# Access Compliance Report

## Public Rights-of-Way

### (Curb Ramps)

Intersection ID: 15070	Main Street: IDEAL_WY	Cross Street: REMOUNT_RD	Location: W
ADA ID: 5B01FE33905B	Ramp Type: Perp	Initial Pass/Fail: Fail	Overall Compliance: No
		Severity Score: 25

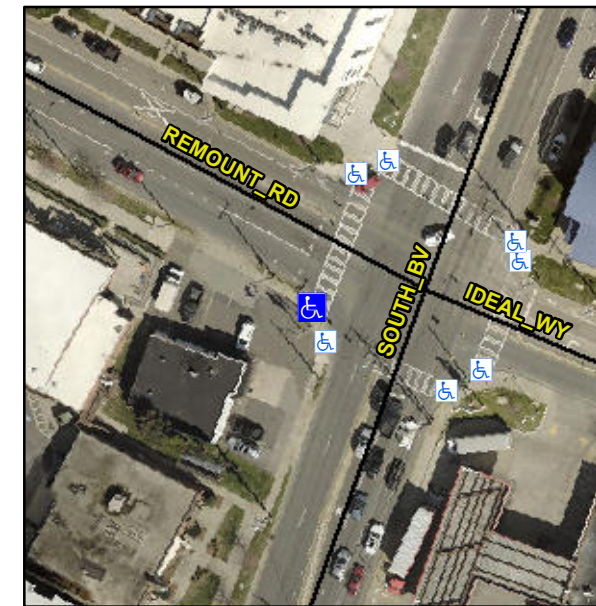
**Not Found, R304.2.2, R304.5.3**

Compliance	Description	Data	Compliance	Description	Data
N/A	Ramp Length (in)	71.0	No	Ramp Slope (%)	8.5
Yes	Ramp Width (in)	48.0	No	Ramp XSlope (%)	5.7
N/A	Flare Type LT	N/A	N/A	Flare Type RT	N/A
N/A	Flare Slope LT (%)	N/A	N/A	Flare Slope RT (%)	N/A
N/A	Flare Traversable LT?	N/A	N/A	Flare Traversable RT?	N/A
N/A	Landing Length (in)	N/A	N/A	DWS Provided?	N/A
N/A	Landing Width (in)	N/A	N/A	DWS Contrast?	N/A
N/A	Landing Slope (%)	N/A	N/A	DWS Length (in)	N/A
N/A	Landing X Slope (%)	N/A	N/A	DWS Full Width?	N/A
N/A	Landing Curb? (Y/N)	N/A	N/A	DWS Offset (in)	N/A
N/A	Shared Landing?	N/A			
N/A	Gutter Ponding?	N/A	N/A	Gutter Slope (%)	N/A
N/A	Gutter Lip Ht (in)	N/A	N/A	Gutter X Slope (%)	N/A
N/A	Painted X Walk1?	Yes	N/A	Painted X Walk2?	N/A
	X Walk 1 Direction	To NE		X Walk 2 Direction	N/A
N/A	X Walk 1 Width (in)	109.0	N/A	X Walk 2 Width (in)	N/A
	X Walk 1 Slope (%)	7.1		X Walk 2 Slope (%)	N/A
	X Walk 1 X Slope (%)	2.7		X Walk 2 X Slope (%)	N/A

**Remove & Replace Entire Ramp.**
